Hannan Fashions Ltd Ext.-1

868, Kalmishor, Shahid Siddique Road, Board Bazar, Gazipur-1704
(Coordinates: 23.942686N, 90.385297E)
Survey Date: 25th March 2015

Observations

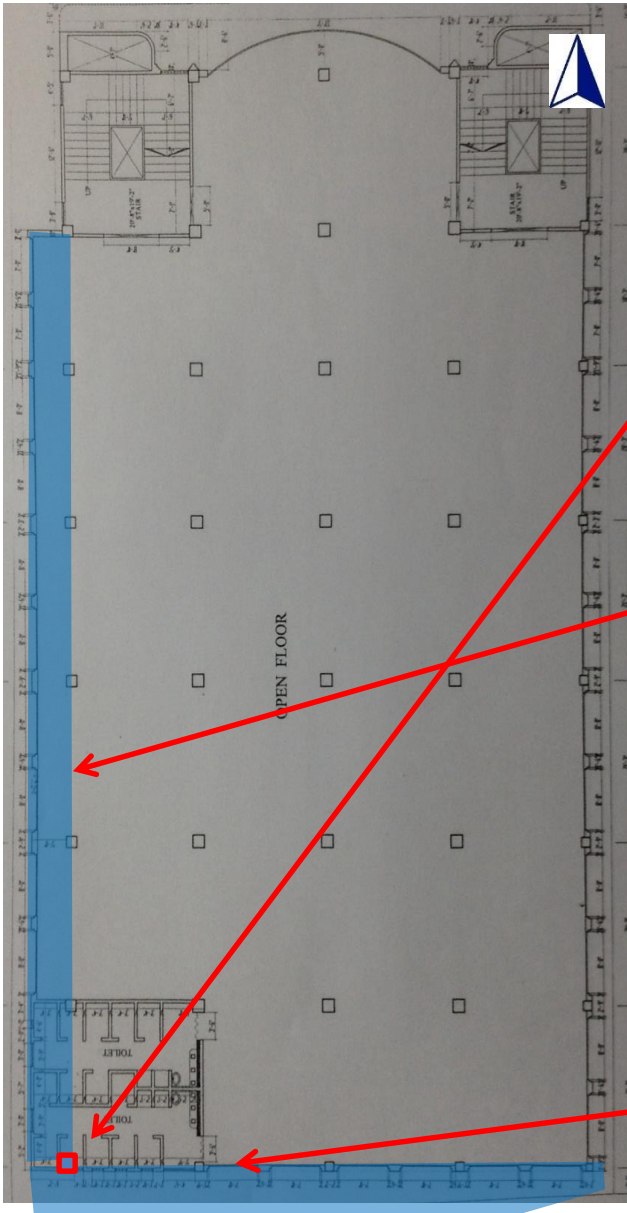
**Moderate to highly stressed
column in toilet area**

**Moderately Stressed Column.
Supported area: Toilets, Cantilever**

Cantilevers

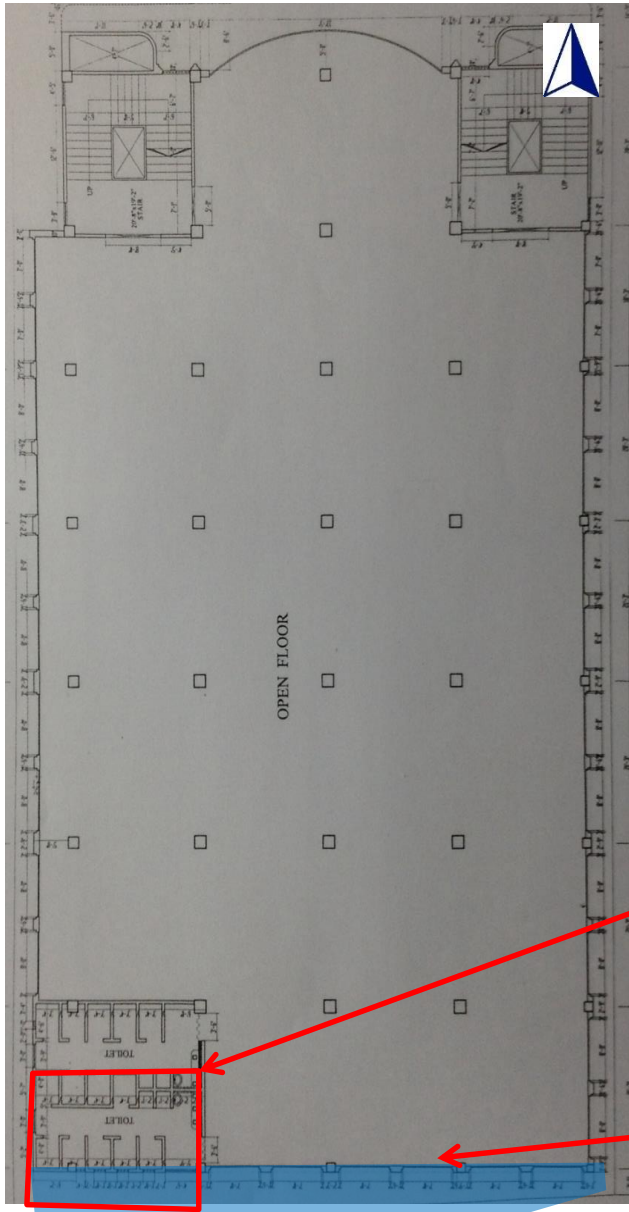
Cantilever is not shown in the drawings

As Built drawing

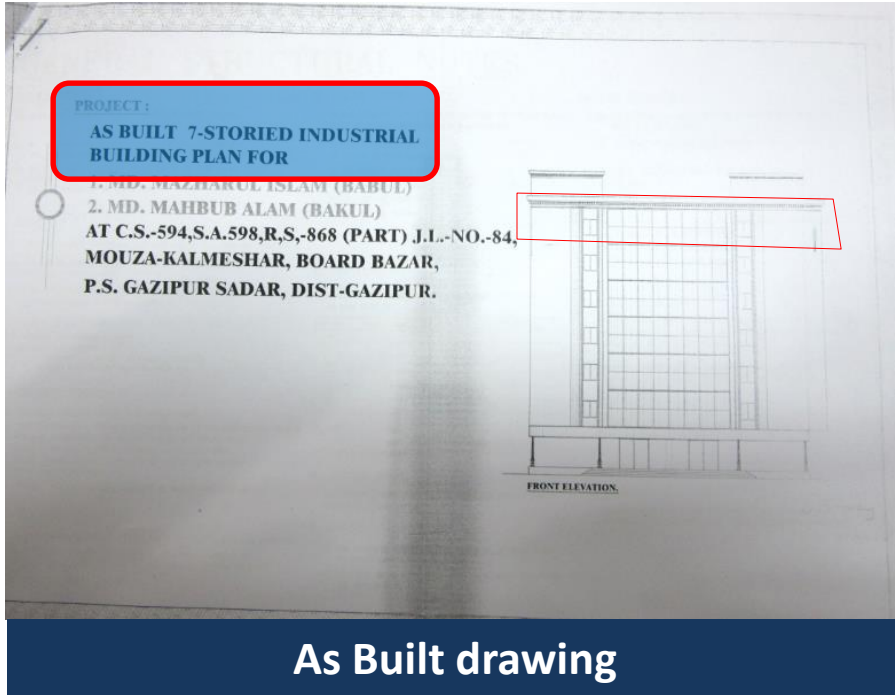
As Built Drawing and permit drawings doesn't match

- As built drawing indicates 7 storey.
- Permit drawing shows 6 storey.
- Actual construction 6 storey plus dining halls at roof.
